**WORCESTER COUNTY TECHNICAL REVIEW COMMITTEE
AGENDA**

PROJECT: Crepe Myrtle Court RPC Step II

WORCESTER COUNTY TECHNICAL REVIEW COMMITTEE MEETING

Project: Step II Master Plan Review –Crepe Myrtle Court Residential Planned Community (RPC). Proposed construction of 25 Two-Family Dwelling Units and one (1) single family dwelling. Located on the southerly side of MD Rt. 707 (Old Bridge Road) west of Keyser Point Road, Tax Map 26, Parcel 157, Tax District 10, R-4 General Residential District, Kathleen Schardt C/O Kathleen Marie Clark, owner/ Iott Architecture & Engineering, Inc., engineer.

UTILITY PLAN

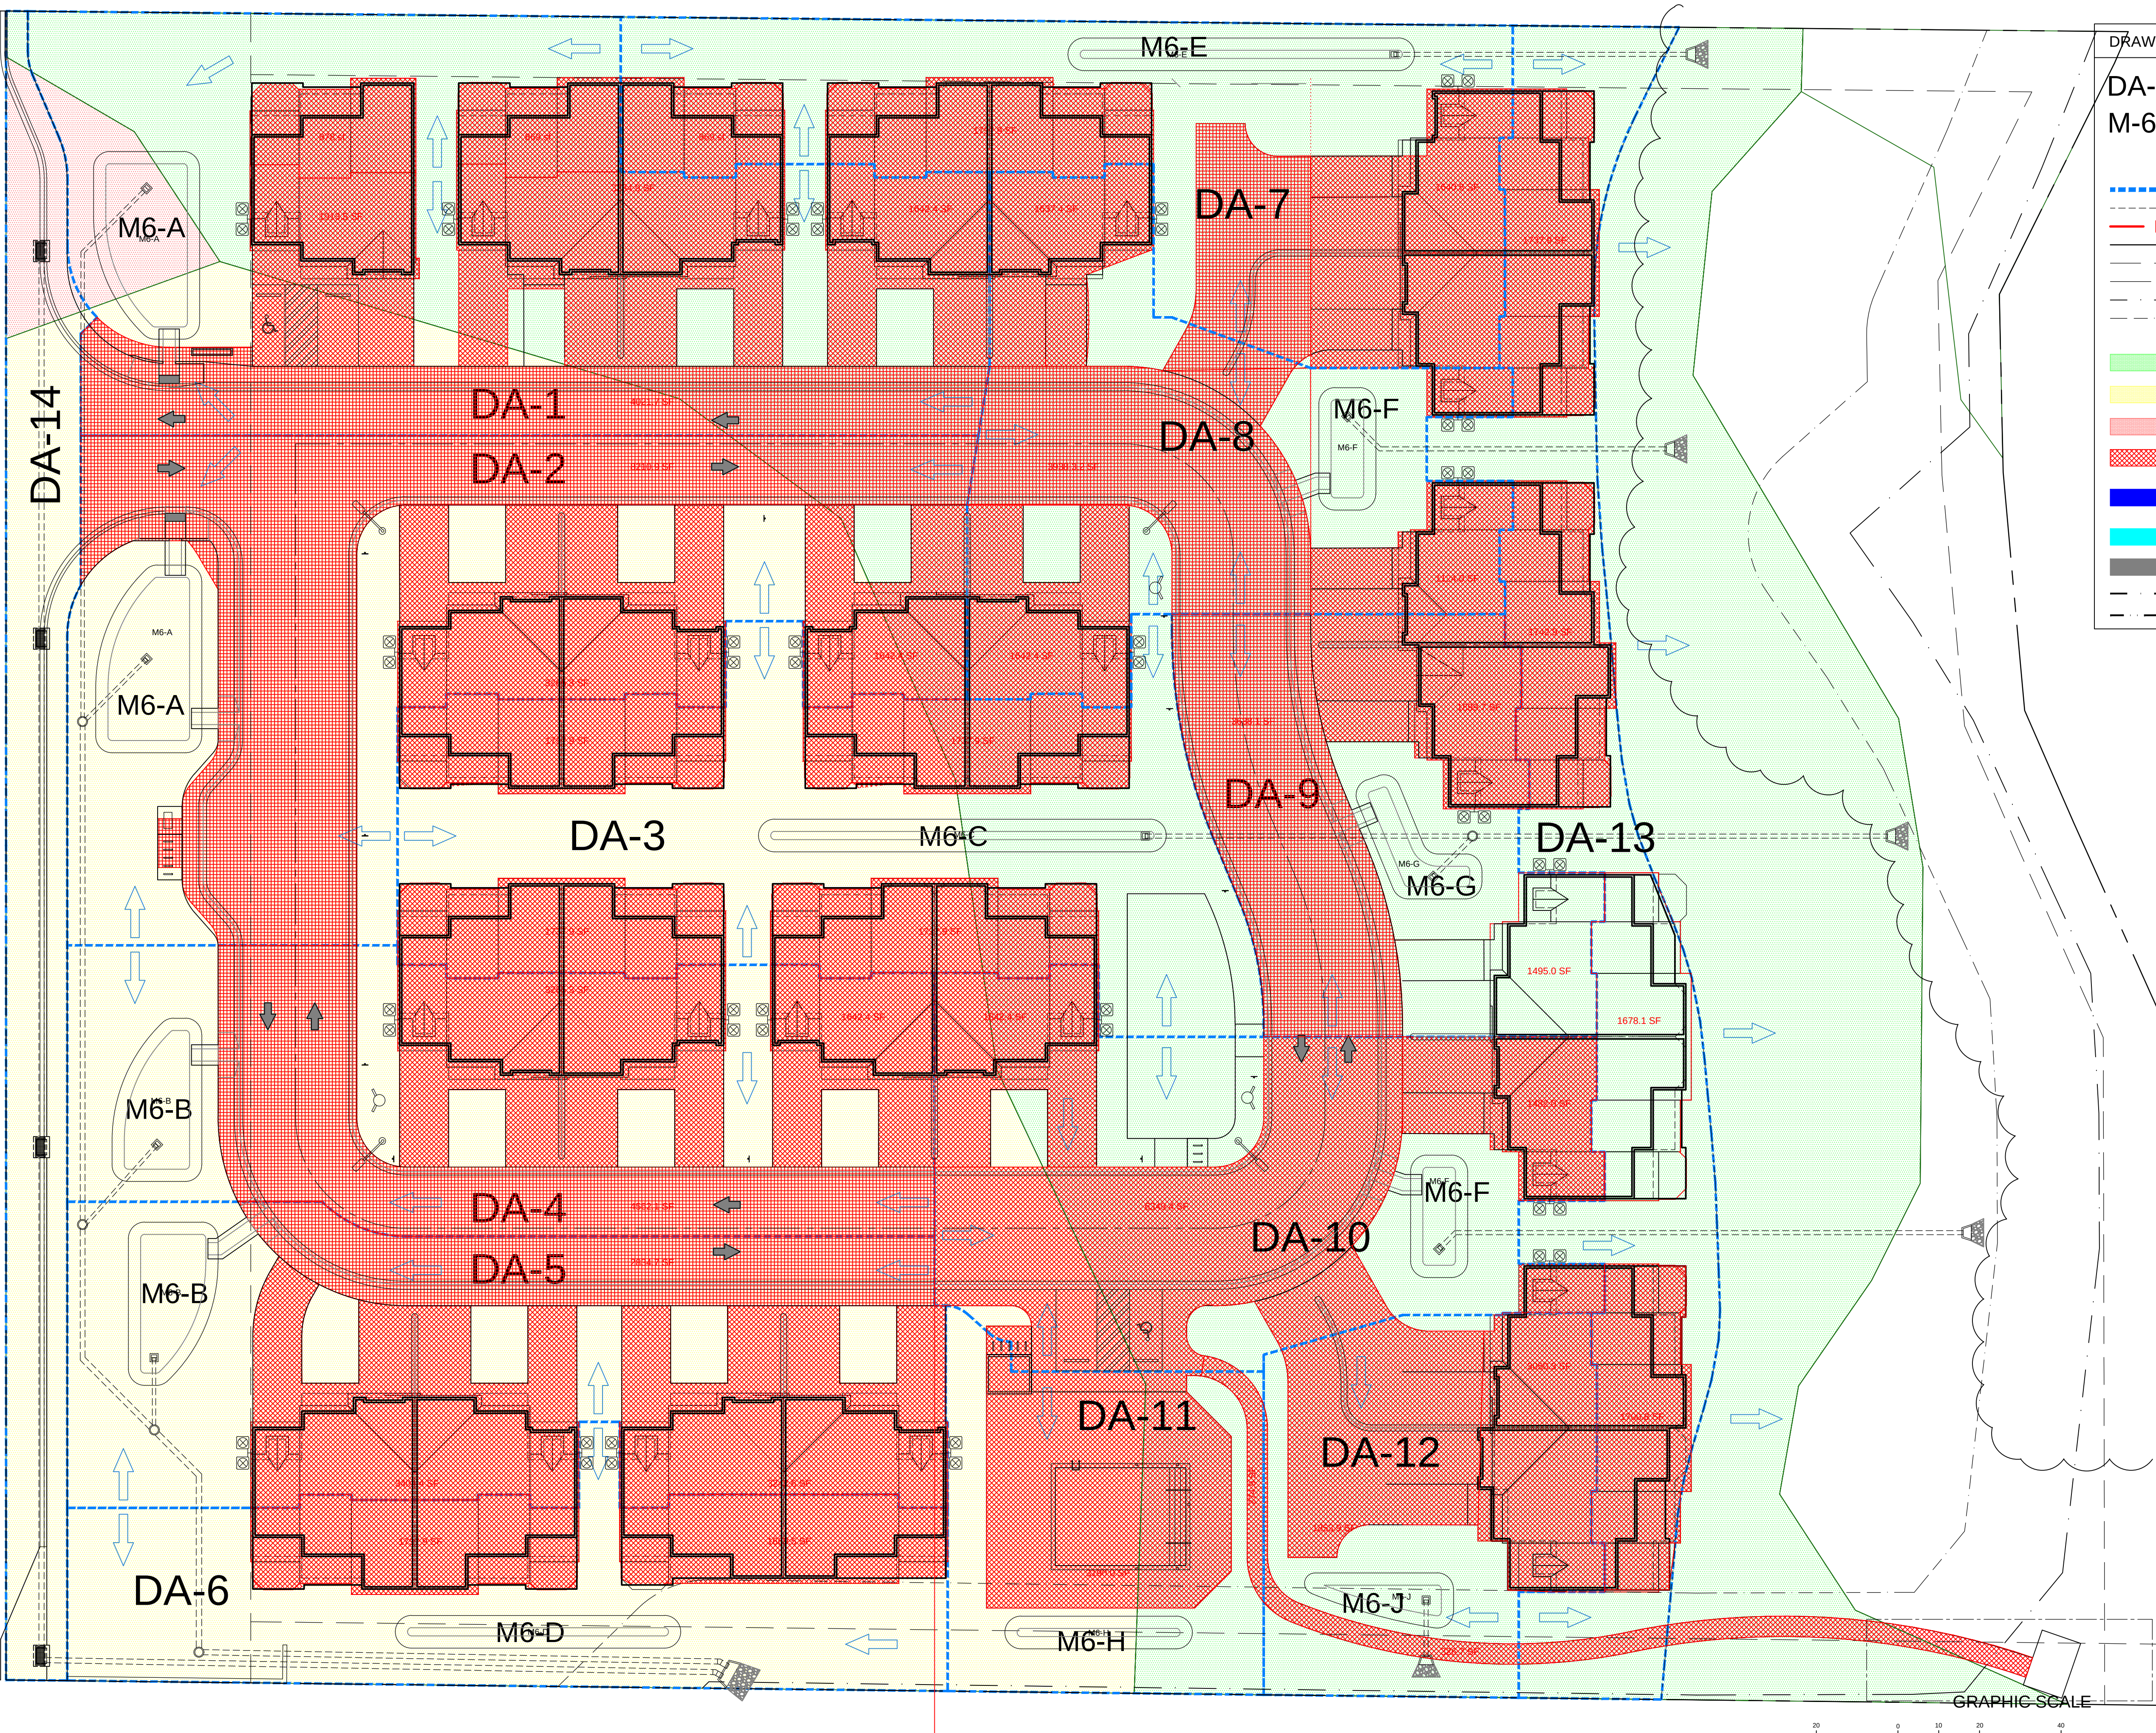
- c. Sheet C-600, is missing building numbers and please include hatching for driveway/paved areas.
 - i. Please show a 10' Worcester County Utility Easement capturing the water/sewer mains, cleanouts, and meter pits. Please relocate any structures, bike racks, or street lights outside of this 10' utility easement.
